# RFP 2024-01 REQUEST FOR PROPOSALS FOR THE BUILD-OUT OF A NEW ANIMAL SHELTER LOCATED AT 427 BEACH ROAD IN HAVERSTRAW, NY ISSUED JULY 25, 2024

To:	All Potential Proposers
From:	Rockland Green
Subject:	Addendum Number 3
Project:	Build-Out of a New Animal Shelter Located at 427 Beach Road in Haverstraw, NY
RFP No.:	RFP 2024-01
Date:	September 30, 2024

(2) new Civil Contract Drawings and revised Civil Contract Drawings to reflect that, in lieu of a new pump station, the existing (undersized) pump station on Site can be removed and replaced with a new (gravity) sanitary sewer lateral to Beach Road, Haverstraw, NY.

PROJECT LOCATION: HAVERSTRAW, NEW YORK CLIENT: ROCKLAND GREEN DRAWING TITLE: SITE REMOVALS PLAN

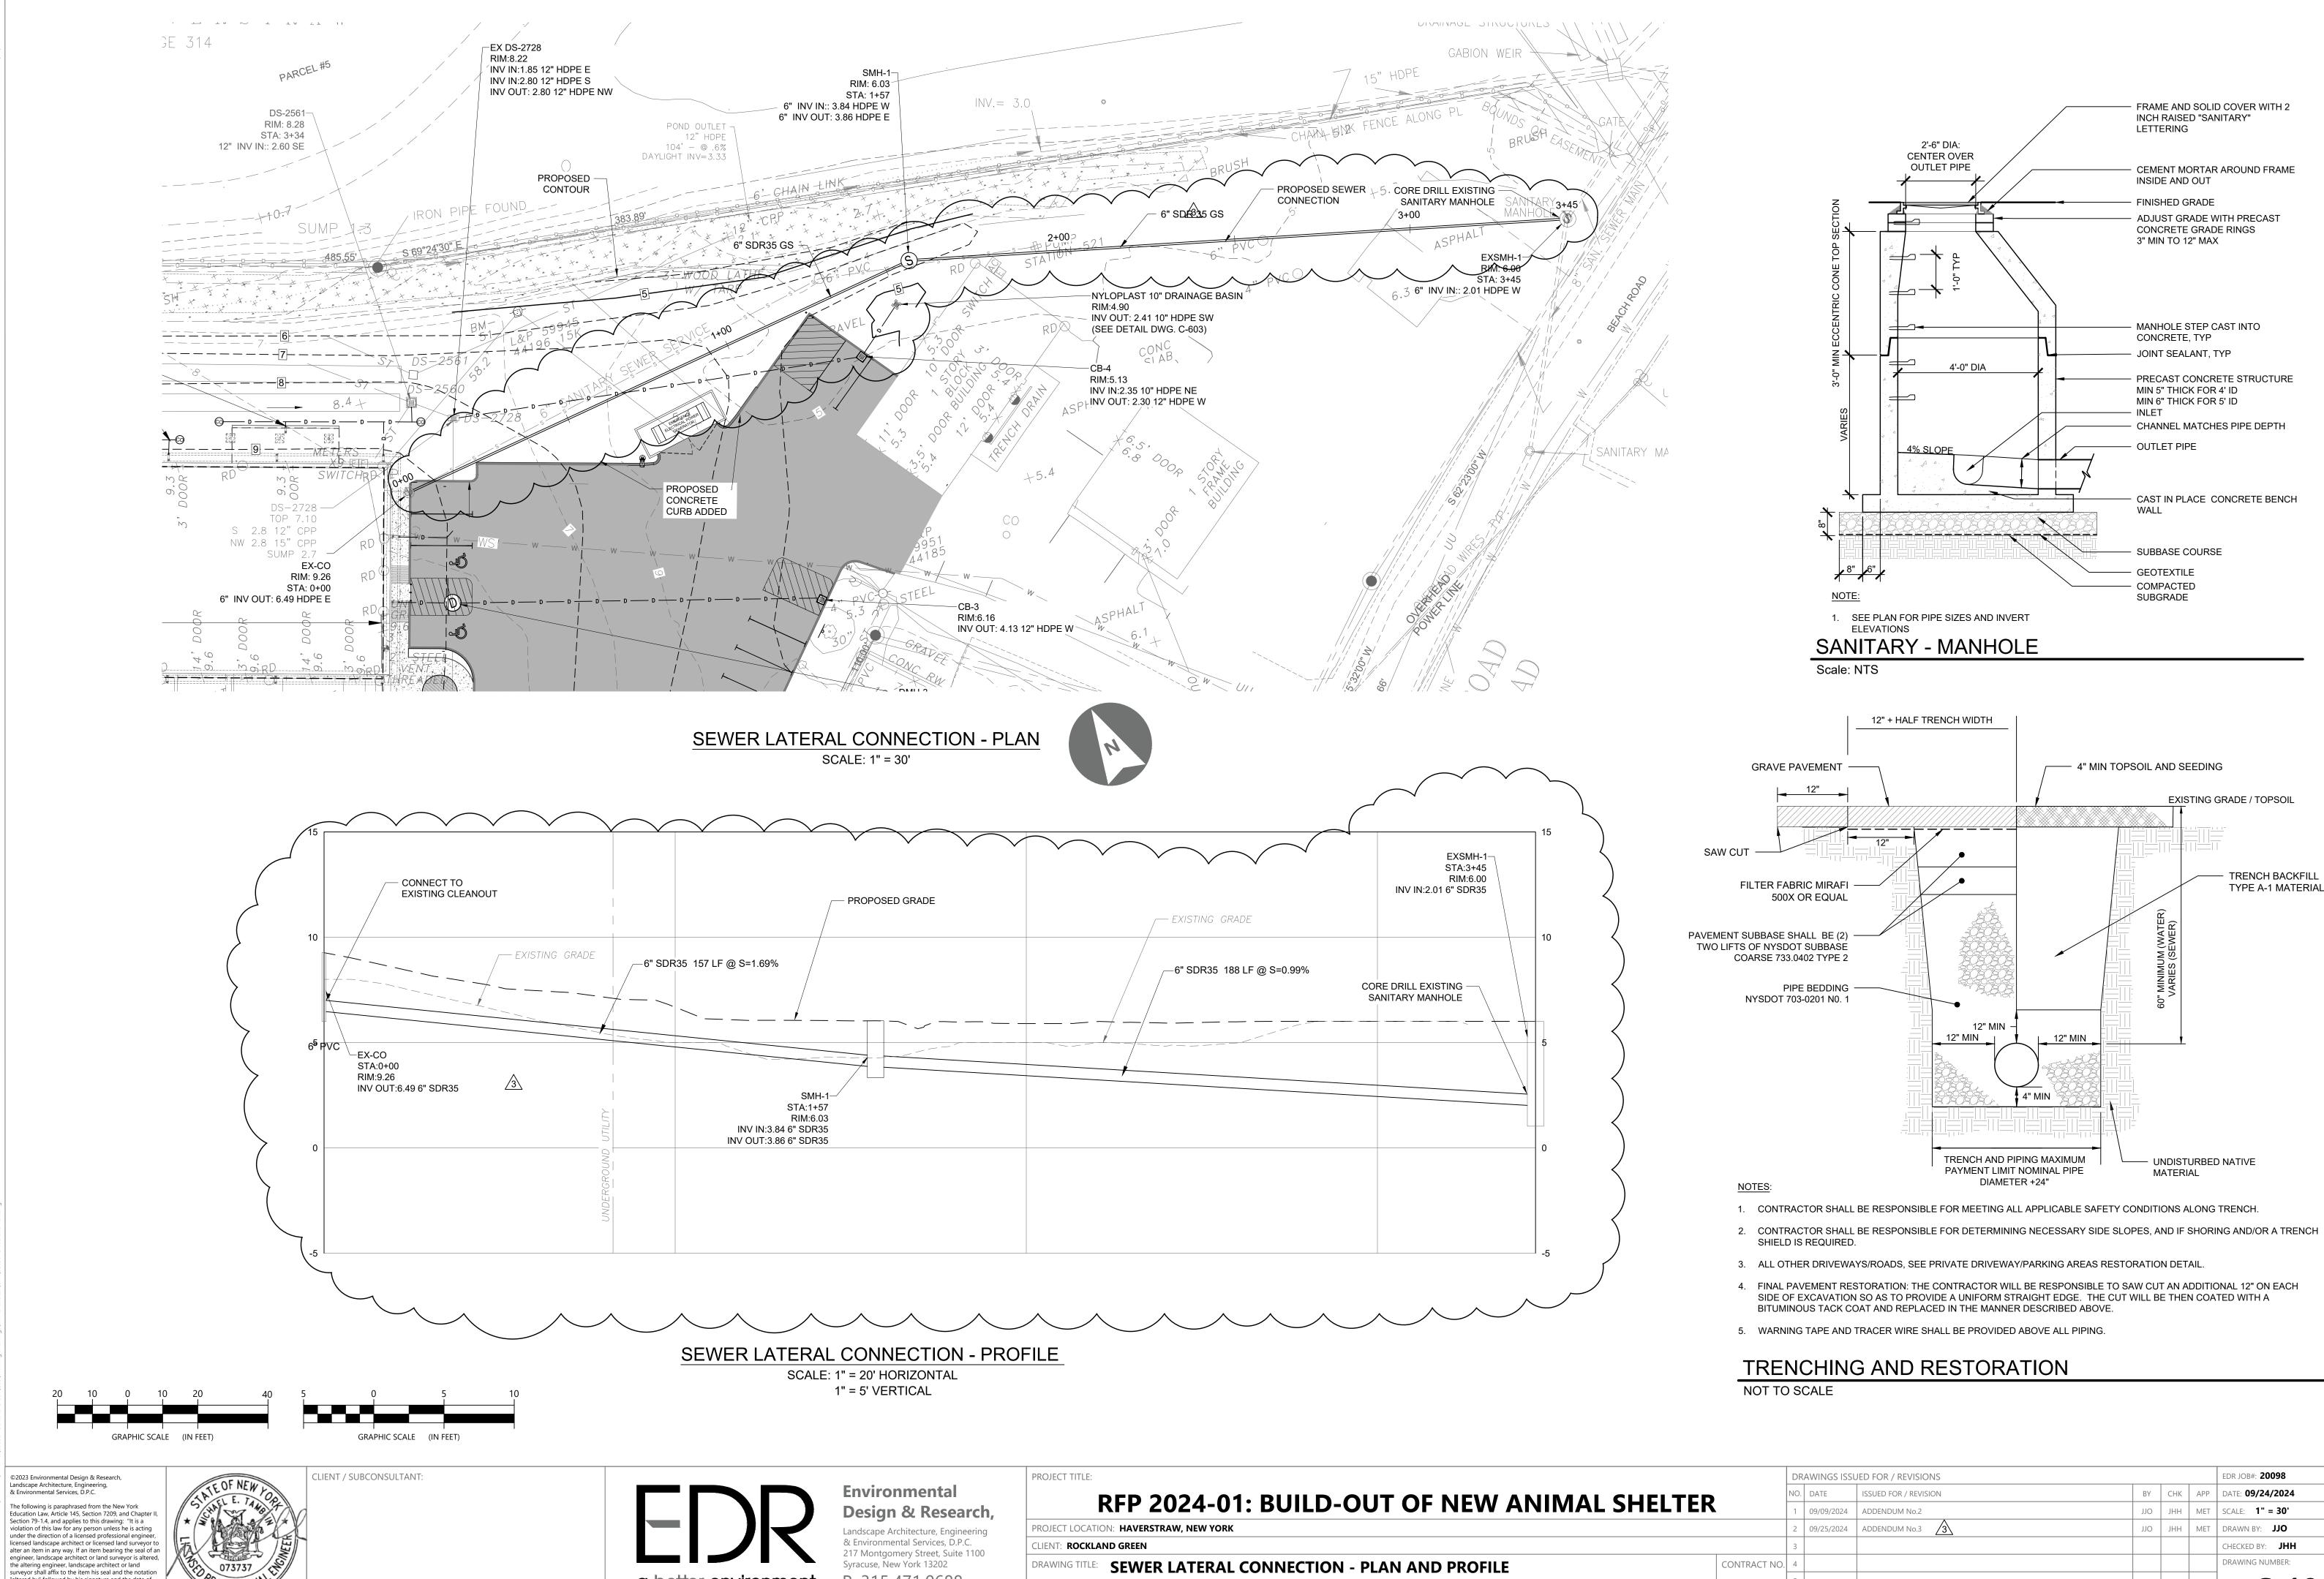
- CG-001 Notes, Abbreviations (Revised for Contract Drawing list and abbreviations)
- C-101 Site Removal Plans (Revised to show removal of existing lateral)
- C-102 Site Plan (Revised with added details)
- C-103 Drainage Plan and Profile (New Contract Drawing to show addition of drain and pipe call for additional soil cover over the new sewer lateral revised grading required additional drainage feature)
- C-104 Sewer Connection Plan and Profile (New Contract Drawing to show new sewer lateral from the building to Beach Road frontage one new manhole and tie-in to existing manhole)
- C-603 Details (Revised to include an additional detail)
